UNITED STATES  
NUCLEAR REGULATORY COMMISSION  
REGION II  
101 MARIETTA STREET, N.W.  
ATLANTA, GEORGIA 30323

SUBJECT: TRANSFER OF LEAD RESPONSIBILITY FOR EVALUATING THE ADEQUACY OF  
THE TRANSFER CANAL SEAL BETWEEN HATCH UNIT 1 AND UNIT 2  
REACTOR BUILDINGS

GPC/NRC MEETING  
FUEL TRANSFER CANAL  
JANUARY 22, 1987

PARTIAL PLAN VIEW OF REFUELING FLOOR

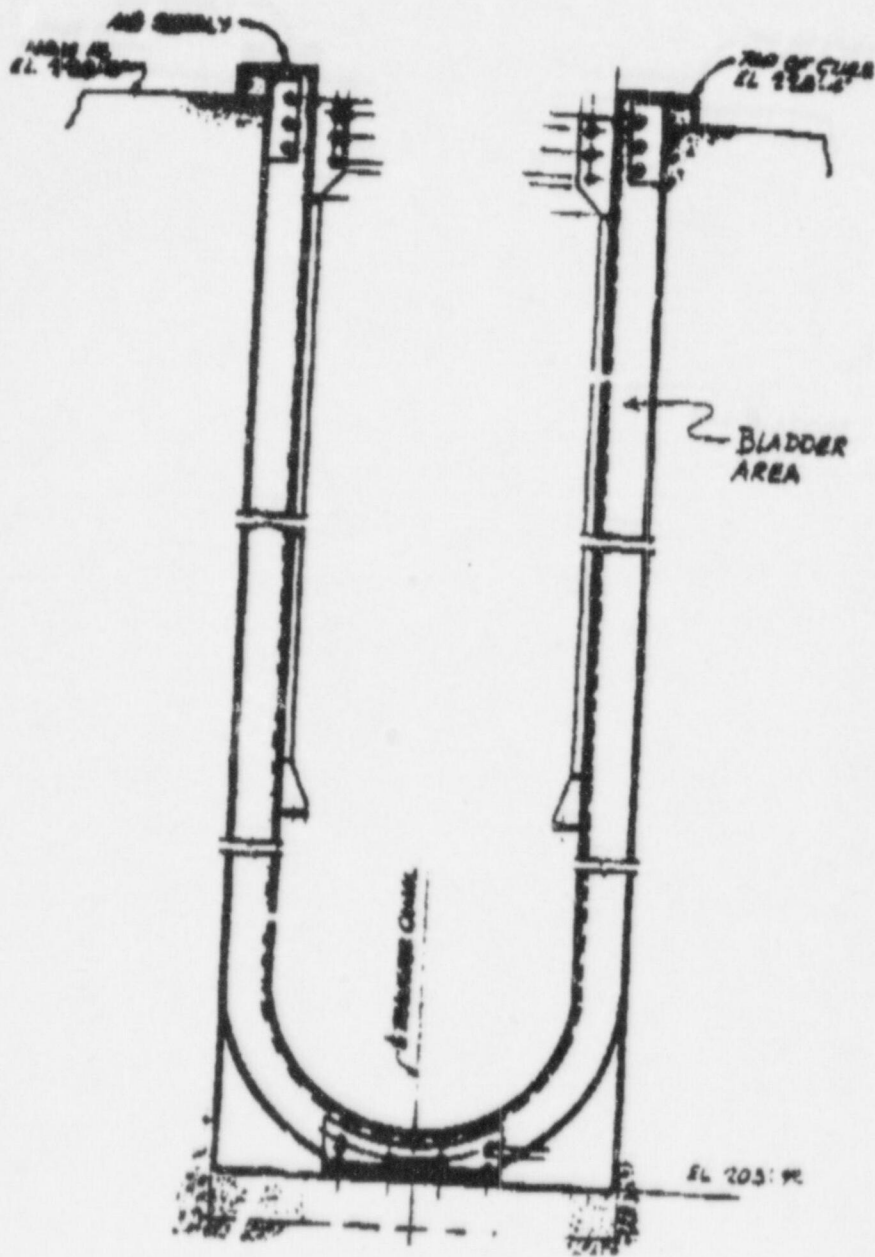
The U-shaped transfer canal, located on the refueling floor between the HNP-1 and HNP-2 spent fuel pools, is removable and as such requires inflatable bellows type seals for watertightness. The seals are located at either end of the canal (horizontal seals), and in the 9-inch space adjacent to the 3-inch seismic gap between the HNP-1 and HNP-2 reactor buildings (vertical seals).

ORIGINAL CONFIGURATION OF  
AIR SUPPLY

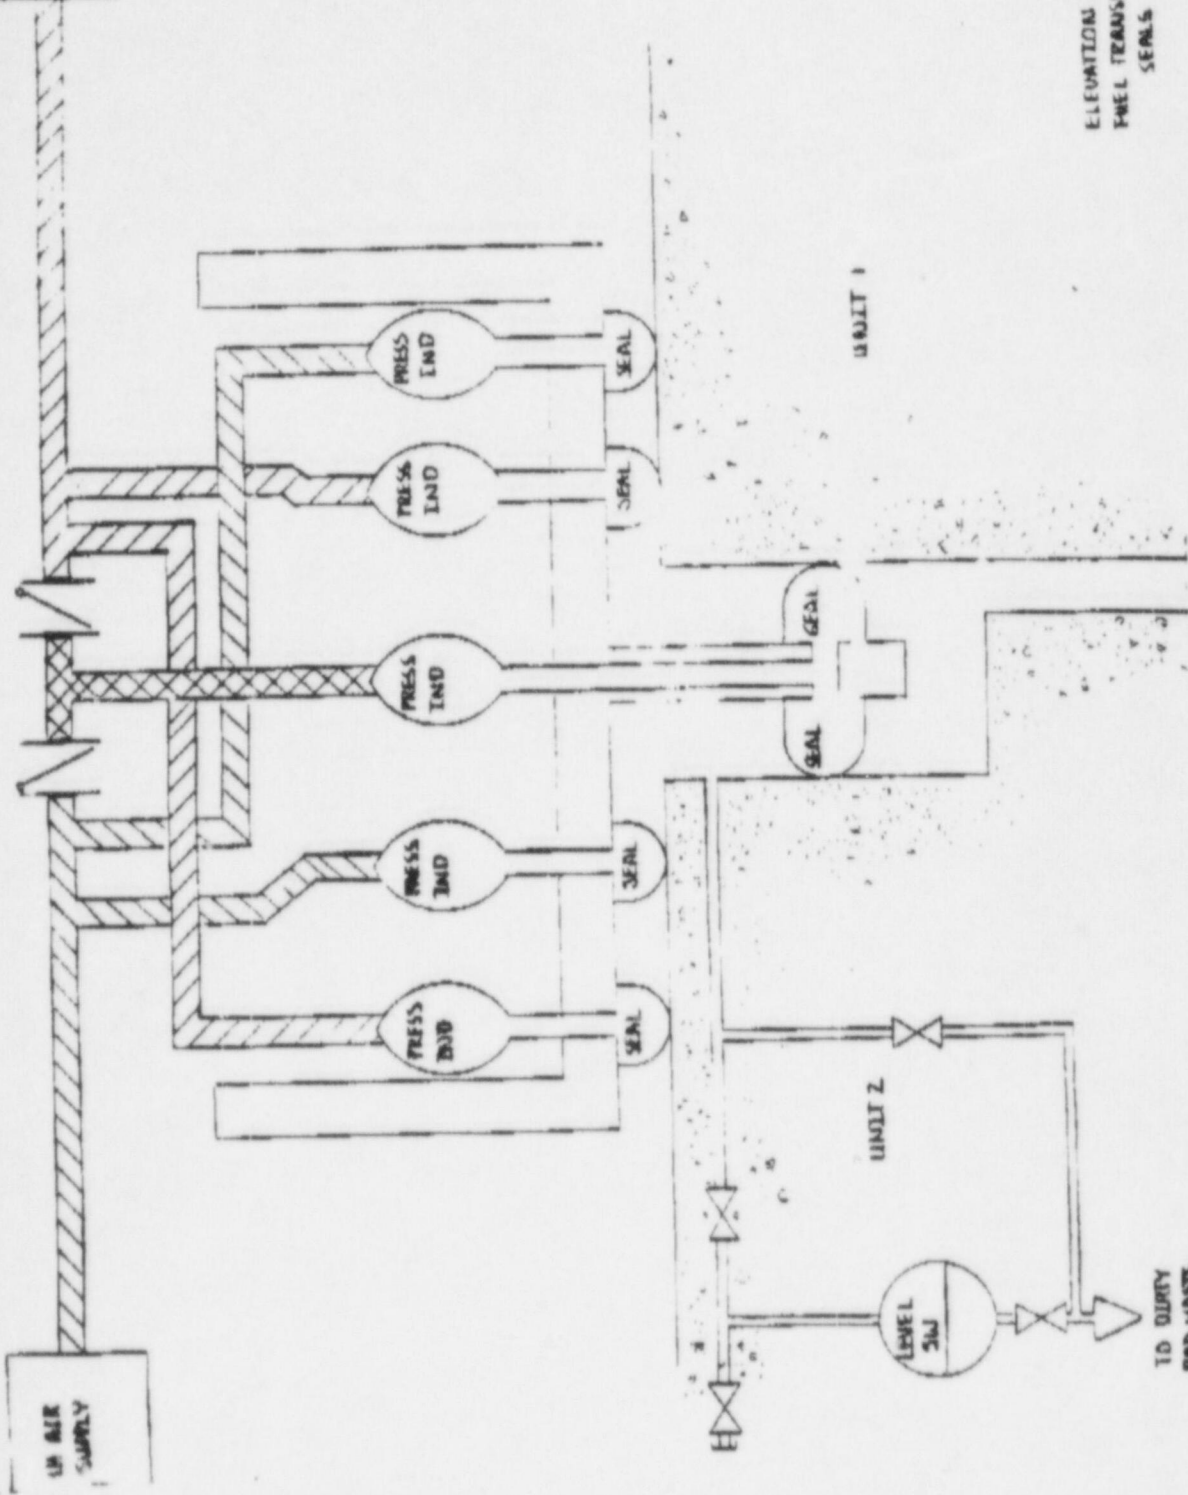
1. In the original design, the transfer canal seals were pressurized by a single feed line from a unit 2 service air system service box which branched into six separate feeds to the individual seals. These lines were equipped with local pressure indicators and check valves. A manual cross tie to the unit 1 air supply is available.

2. Subsequent to the fuel pool leak down, several changes were made to improve reliability of the air supply. A second supply from HNP-1 service air was incorporated such that in each horizontal seal pair, one is fed from HNP-1 service air, and one is fed from HNP-2 service air. In this arrangement, loss of, say, the whole unit 2 air system will not affect but one of the seals in the pair and system integrity is maintained (transfer canal seal system). A common line was incorporated to supply the vertical seals with both HNP-1 and HNP-2 service air. Check valves placed in the feed piping to this common header prevent back flow upon loss of air from one unit or the other. Other changes included the addition of pressure switches that would alarm in both control rooms upon a drop in pressure in either supply. ] answer system
